Proposal: The applicant is requesting approval to partition a 1.95-acre parcel into three parcels of approximately 44,720 square feet, 14,936 square feet, and 25,299 square feet with access from NE Canter Avenue. Street improvements for NE Canter Avenue are proposed.

Based on the above findings of fact, and the conditions of approval, the proposed project satisfies the applicable criteria and staff tentatively approves the Partition Application No. PA 21-01, Smith-Canter Partition, pursuant to the conditions of approval listed below. A final determination will be issued after the agency/public comment period and all comments are taken into consideration.

TENTATIVE PARTITION

Progressive Design Builders, Inc.- Stephen Smith
 SW 1/4, SECTION 16, TOWNSHIP 10 SOUTH, RANGE 3 WEST, W.M.
 ALBANY, LINN COUNTY, OREGON
 DATE PREPARED: March 05, 2021

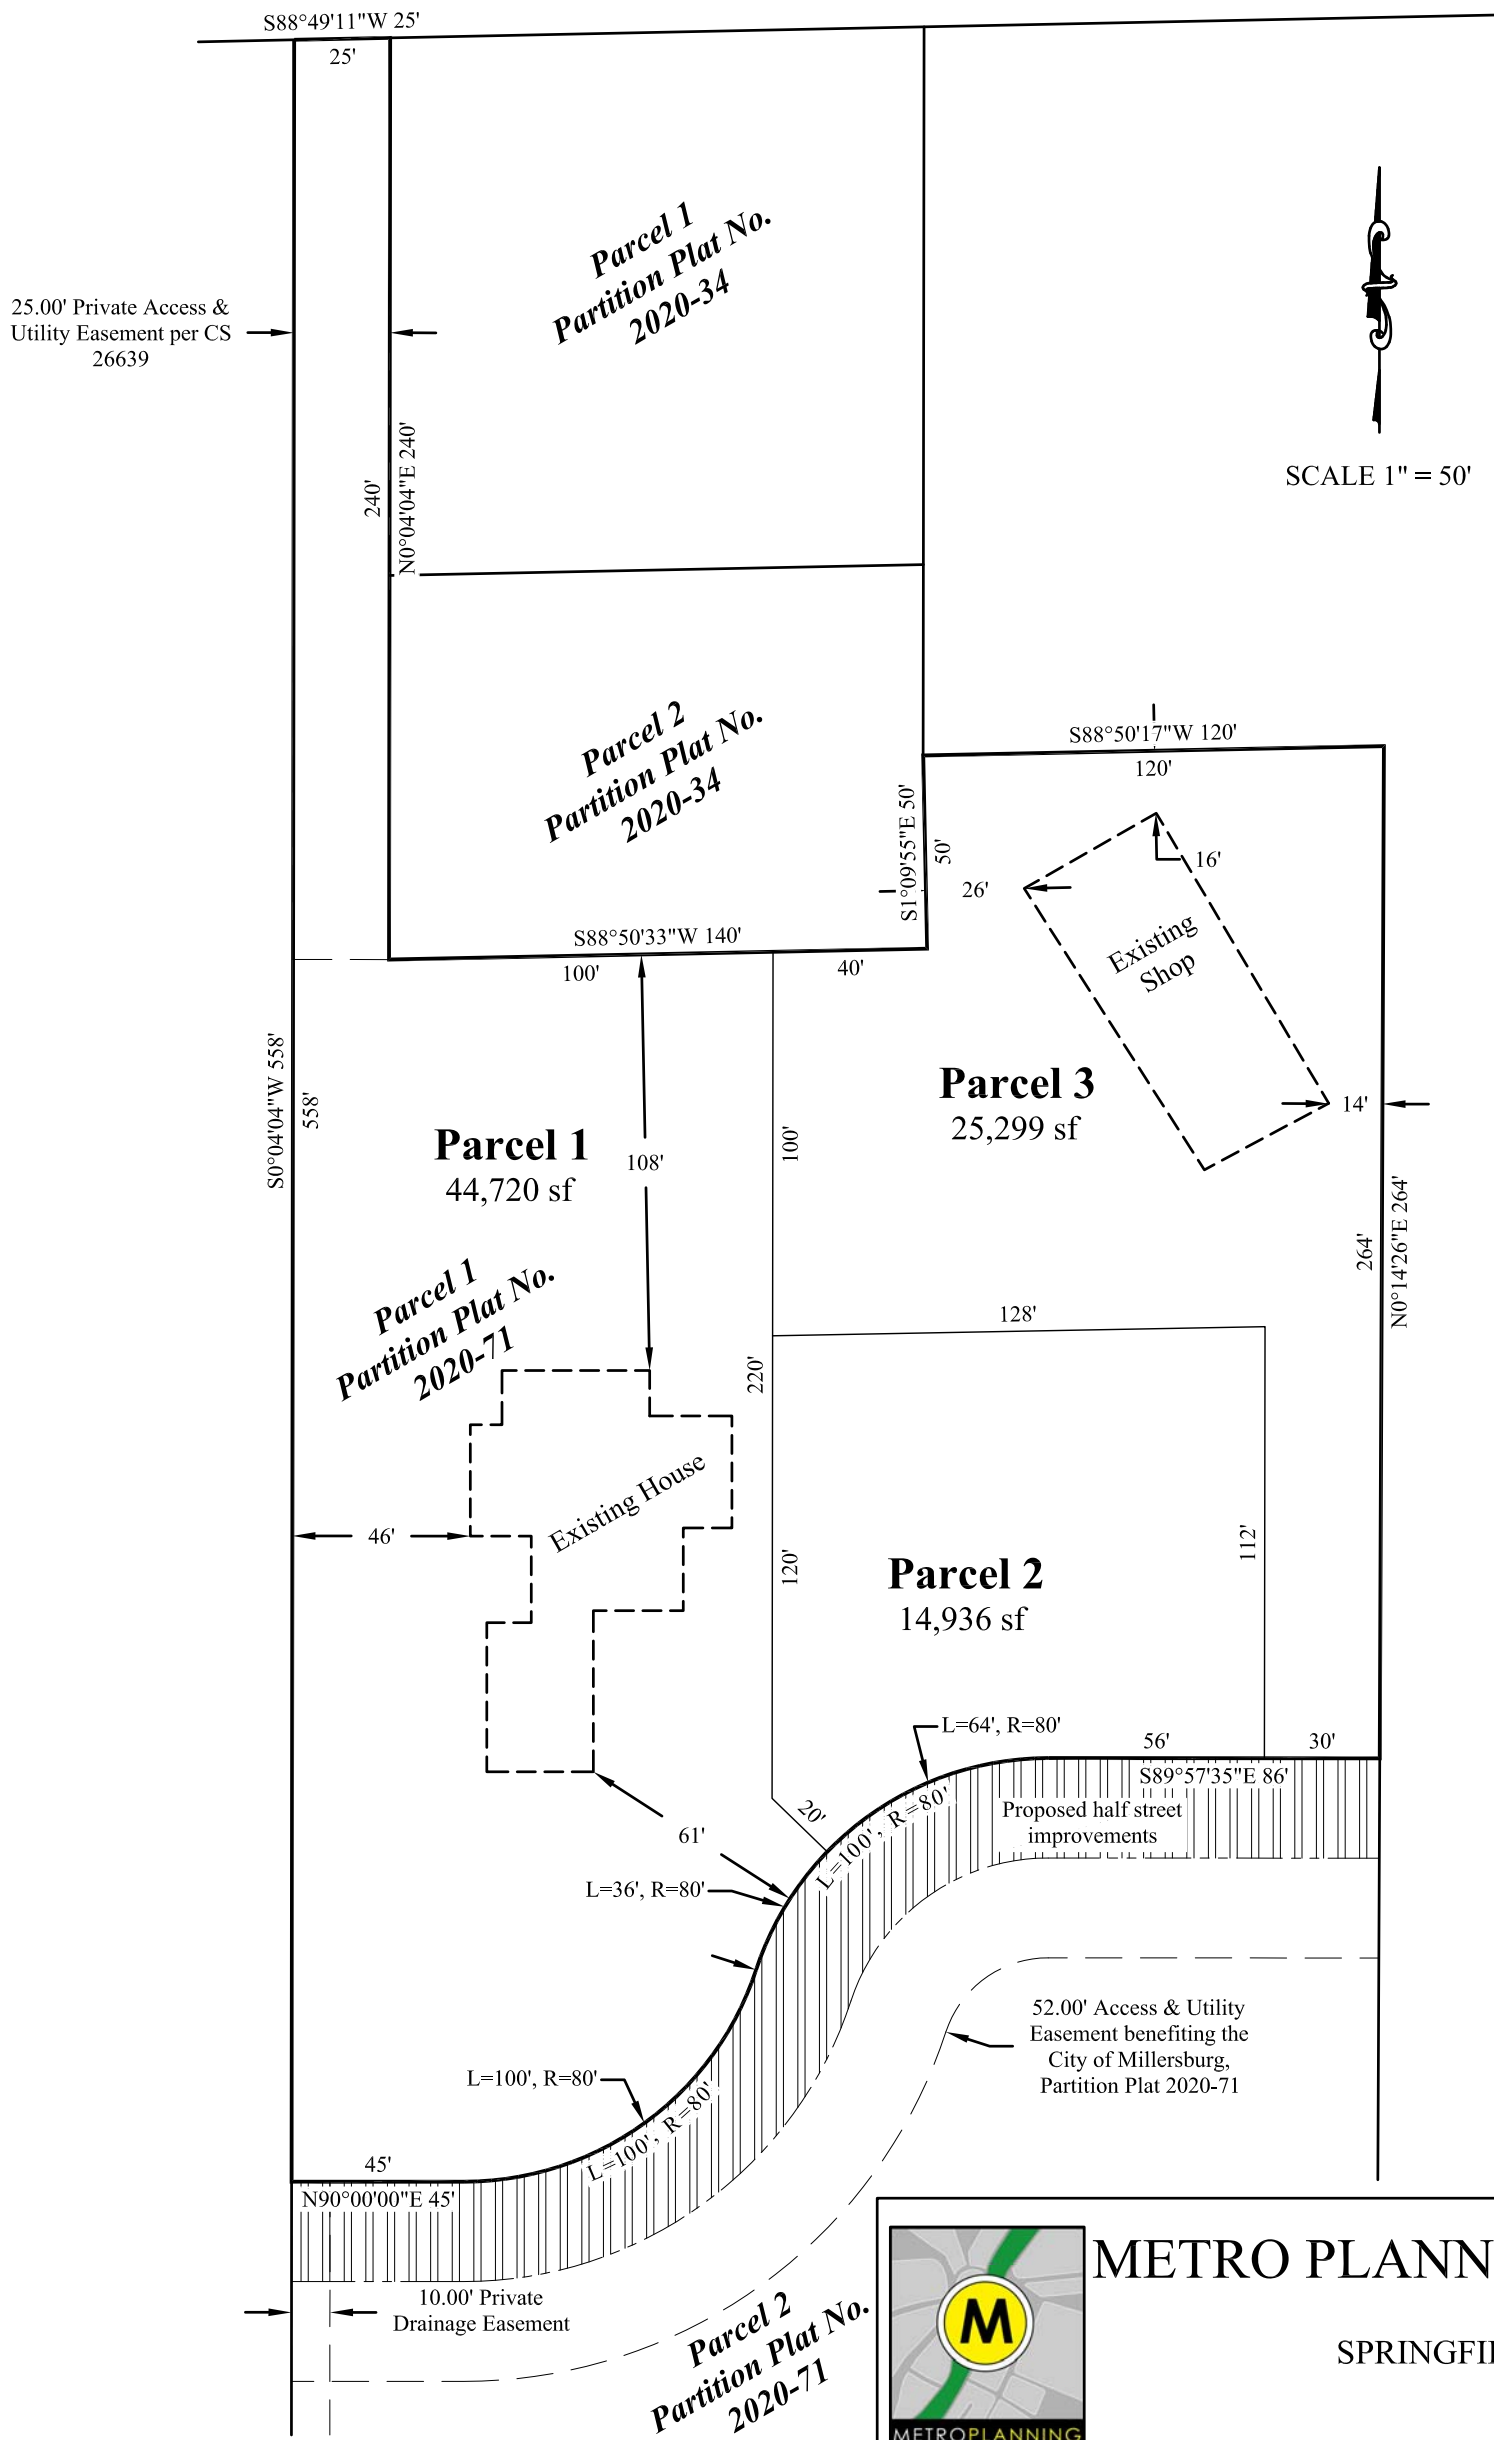
ANALYSIS: The proposed map shows street improvements along Canter Avenue, along the southern edge of the property. No sidewalks are shown, though they are required. The street is shown in diagrammatic form only; no street specifications are provided, nor are public utility connections or locations of the connections. All will need to be provided and constructed prior to the recordation of the final plat.

ANALYSIS: The proposed map shows the general location of street improvements, but does not include details of the proposed construction. Connections to the property on the west are provided, and the street will be constructed to the west side of the property. The extension of NE Canter Avenue will follow the same width and construction details as exist currently to the east of the site on the section of NE Canter Avenue that has already been constructed.

ANALYSIS: A storm drainage plan was not provided by the applicant but will be required to assure the project meets the standards of this section. A condition of approval has been added to require the submittal and approval of a plan prior to any development of the property.

ANALYSIS: The project proposes three parcels. Parcel 1 is proposed to be about 230 feet deep and about 100 feet wide; parcel 2 is proposed to be about 112 feet deep and about 128 feet wide; parcel 3 is a flag lot proposed to be about 150 feet deep and about 150 feet wide. All of these meet the lot to width ratio requirements. Parcels 1 and 2 have more than the 40 feet of frontage required, and parcel 3 is a flag lot with a 30 foot wide access strip. The required 14 feet of improved surface is not shown; a condition of approval has been added. None of the parcels are considered through parcels, and all lot lines are some form of a right angle.

ANALYSIS: As discussed in other sections, conditions of approval require full construction of street improvements and sidewalks. This section also specifies that street lights are required. The applicant did not show any proposed street lighting. As such, a condition of approval has been added for the construction of street lights prior to the City approval of the final plat.

- Prior to City approval of the final plat, the applicant shall provide details of all street and public utilities for review and approval. The design of NE Canter Avenue shall follow the same width and design as the existing

section of NE Canter Avenue to the east of the project site.

- Prior to City approval of the final plat, the applicant shall construct all streets, sidewalks, and public utilities, or provide bonding (or similar) for all improvements, to the satisfaction of the City Engineer. The applicant must have all improvements approved by the City.
- All right-of-way for NE Canter Avenue shall be dedicated as part of the final plat.

- Prior to City approval of the final plat, the applicant shall submit for approval a drainage plan for the site that meets all the requirements of the Millersburg Development Code Chapter 3.04, to the satisfaction of the City Engineer.

- Parcel 3 shall include an improved driveway surface of at least 14 feet wide within the 30 foot access strip.

- Prior to City approval of the final plat, the applicant shall provide details of all street lights for review and approval. The design of the street lighting shall follow the pattern already established on NE Canter Avenue east of the project site.
- Prior to City approval of the final plat, the applicant shall construct all street lighting or provide bonding (or similar) for all improvements, to the satisfaction of the City Engineer. The applicant must have all improvements approved by the City.
